# Recall Campaign Bulletin

Campaign No. 2024010011, July 2024

Revision A: 08/05/2024

## **Replace Fuel Pump Delivery Module – Wave 4**

**Figure 2**

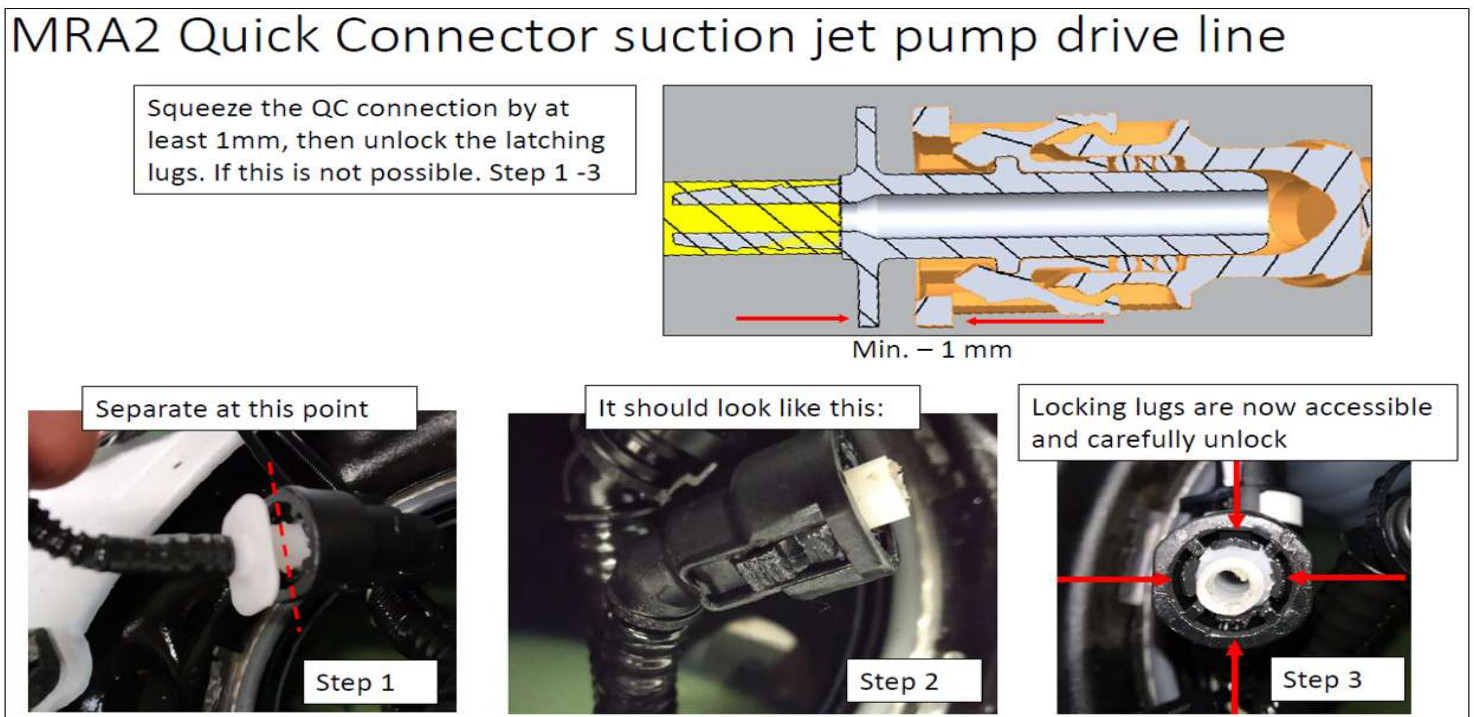
**i** **Only model 206, 232:** Note on disassembly of suction jet pump drive line quick connector.

The procedure steps 1-3 should only be performed when the quick disconnect is not working (**Figure 2**).

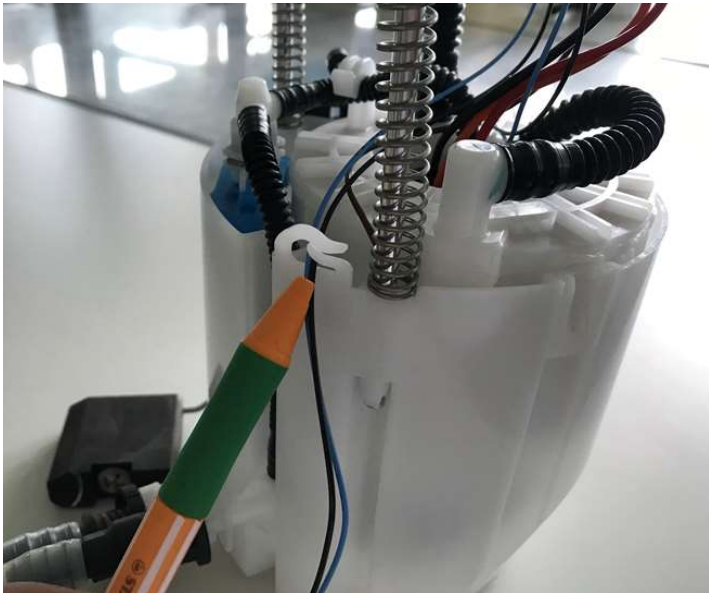
**i** **Only for model 167**

Contrary to the WIS document (**AR88.60-P-2001ME - Remove/install tank filler recess**), the tank filler recess must **not** be removed. Disconnecting the hose lines at the activated charcoal canister and the sealing bellows on the inside at the tank filler recess is sufficient.

**Figure 3**

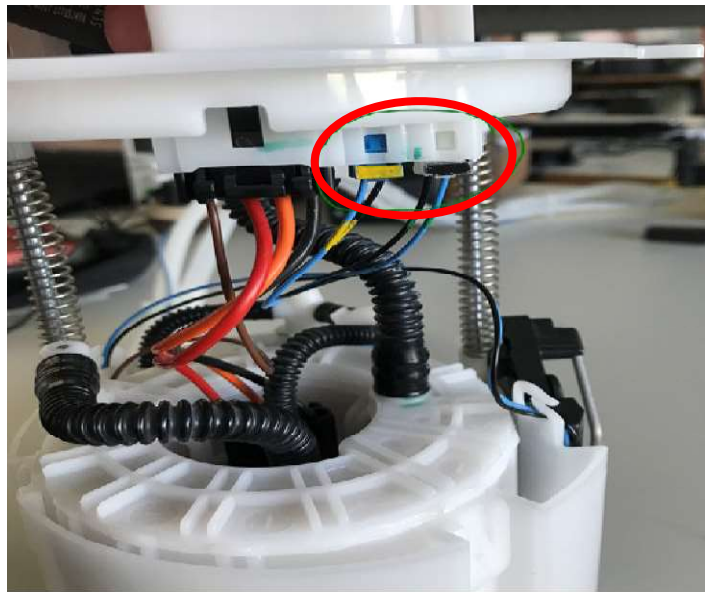
**i** For **all** vehicles with code 228 stationary heater, the connection for the fuel supply system must be cut off before installing the fuel pump (**Figure 3**).

**Figure 4** (remove electric lines from routing clip)

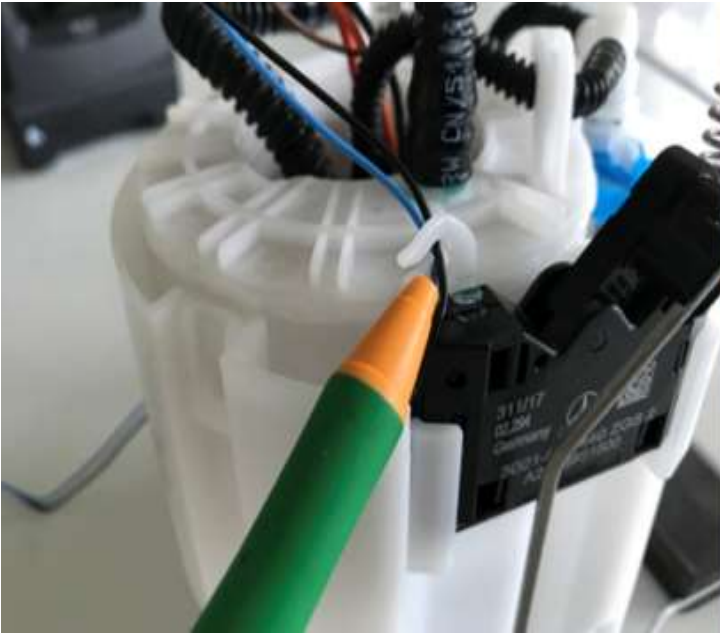
**i** Delivery modules that are delivered **without float-and-lever sensor** must be modified. (**Figure 4-7**)

**Figure 5** (release corresponding connector and disconnect the contacts)

**Figure 6** (remove lines from routing clip)

**Figure 7** (using a screwdriver, carefully push float-and-lever sensor housing away from module housing and at the same time push float-and-lever sensor housing upwards.)
